STAFF REPORT: AUGUST 9, 2023 REGULAR MEETING **PREPARED BY:** T. BOSCARINO
APPLICATION NUMBER: 23-8482
ADDRESS: 630 VIRGINIA PARK
HISTORIC DISTRICT: NEW CENTER AREA
APPLICANT/OWNER: JOE GUADAGNINO
DATE OF PROVISIONALLY COMPLETE APPLICATION: JULY 17, 2023
DATE OF STAFF SITE VISIT: JULY 19, 2023

SCOPE: REPLACE FRONT DOOR, TRANSOM, AND SIDELIGHTS

July 2023 photo by staff.

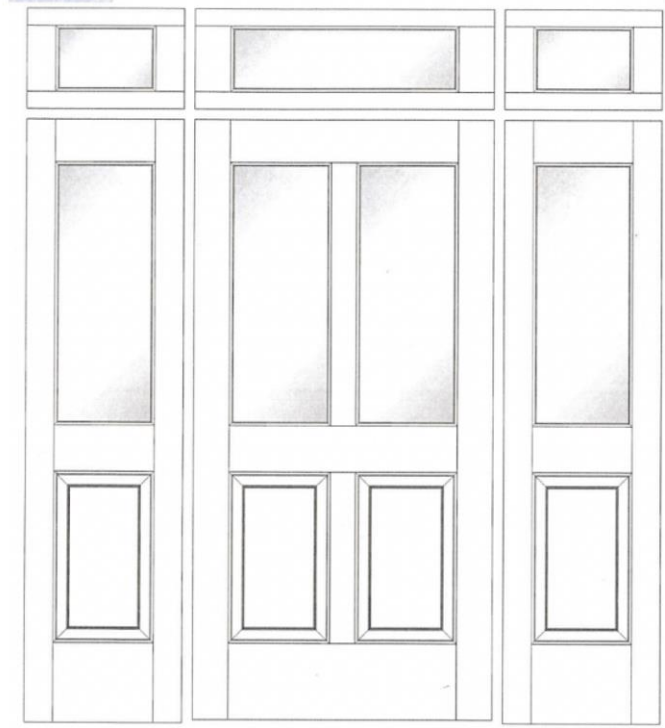
Built in 1906, the property at 630 Virginia Park is a two-and-one-half story building, located midblock and facing south towards the street. It is an English Revival or Tudor Revival house, clad in brown brick. Character-defining features include the asymmetrical façade with a dominant Tudor-style gable that projects forward from the east side of the front façade. On the west side of the front façade, a covered porch with a limestone cap also projects from the centrally located front entrance. Above, expressive fascia boards and half-timbering in the upper portion of the gables are supported by decorative dentils. An articulated gable aligned with the front door projects past the rest of the porch canopy and balances the composition of the front façade. Within the doorway, a door surround (subject of this application) with transom and sidelights is also a defining feature. Windows were replaced in 2020 or 2021.
